# UNITED STATES PATENT AND TRADEMARK OFFICE

APPLICATION NO.	FILING DATE	FIRST NAMED INVENTOR	ATTORNEY DOCKET NO.	CONFIRMATION NO.
10/669,533	09/24/2003	Jeffrey A. Lucas	61605US003	4631
32692	7590	04/28/2006	EXAMINER	
3M INNOVATIVE PROPERTIES COMPANY PO BOX 33427 ST. PAUL, MN 55133-3427			CECIL, TERRY K	
			ART UNIT	PAPER NUMBER

## Office Action Summary

## DETAILED ACTION

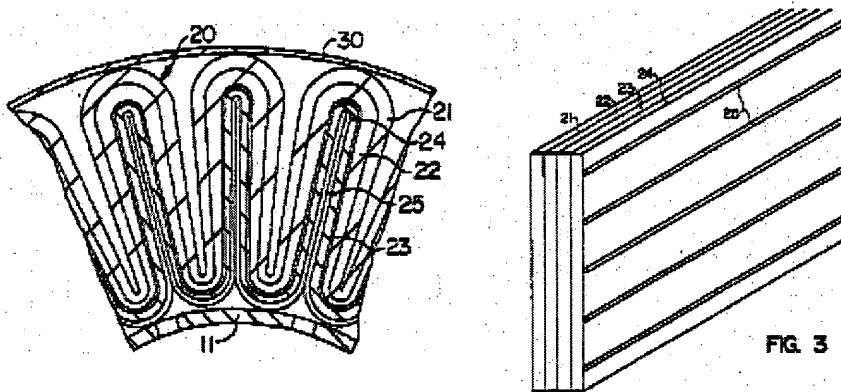
Miller teaches a filter element including a filter media 23, an upstream support 21 and a multi-layer downstream support 22 and 24 (note that the cushioning layer can be between the filter layer and either of the upstream and downstream supports, see col. 4, lines 17-21). The second downstream support layer 24 includes "ribs" 25 [as in claims 1, 6, 12, 13 and 22]. The cushioning layer (or first downstream support, see col. 8, lines 42-45) is a thin, highly porous,

nonwoven, polyester layer made by a wetlaid process (col. 5, lines 29-46) [as in claims 7, 9-10, 14 and 16-17]. The examiner considers such a layer made by the same process and material disclosed by the applicant and having a thickness less than 100 microns yet being highly porous as having its surface contact points “minimized”. As shown in e.g. figures 1 and 6, the filter element includes a perforated core, an outer cage and end caps [as in claims 13 and 20-21]. The filter media is pleated to have longitudinally-extending, radial pleats [as in claims 2-3].

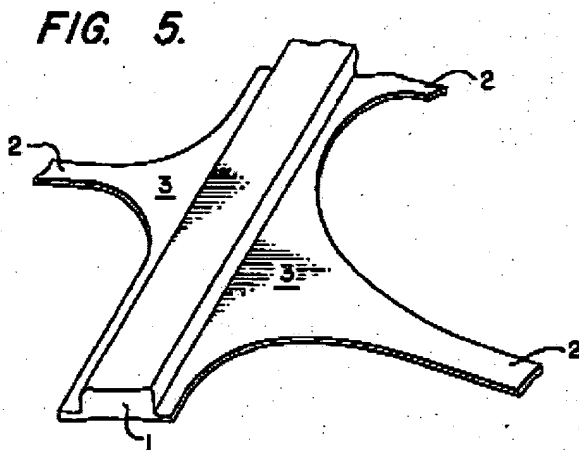
Although Miller teaches his second downstream support can be *any* woven or nonwoven material (col. 4, lines 39-40) and cites an extruded, apertured, polymeric, mesh having “ribs” 25 as an example, he doesn’t mention the layer being an extruded apertured film. However, such is taught by Rasmussen (U.S. 3,954,933). As shown in figure 5 below and also figures 2-3,

Rasmussen teaches a layer comprising an extruded, apertured, polymeric film having ribs 1 and portions 2, 3 between apertures [as in claims 1, 11, 13, and 22]. It is considered that it would have been obvious to one ordinarily skilled in the art at the time of the invention to have at least the

second downstream support layer of Miller to be the film layer of Rasmussen, since Rasmussen teaches the benefits of a reinforcement that is thin, strong, and inexpensive and that *can be used in filters* (col. 1, lines 8-13).
